# CITY OF ELKO

### REQUEST FOR QUALIFICATIONS ONE (1) NEW SERVICE TRUCK WITH BODY AND CRANE FOR THE WRF QUESTIONS/ANSWERS

October 15, 2018

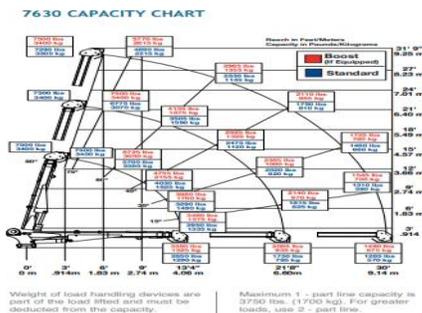
2. There is also a requirement stated that the crane lifting moment shall be minimum 40,000 lbs. What is meant by that? I was told you might be looking for something similar to the Stellar crane model below:

**Answer: The Stellar 7630 crane is within our requirements/expectations. See Pictures Below.**
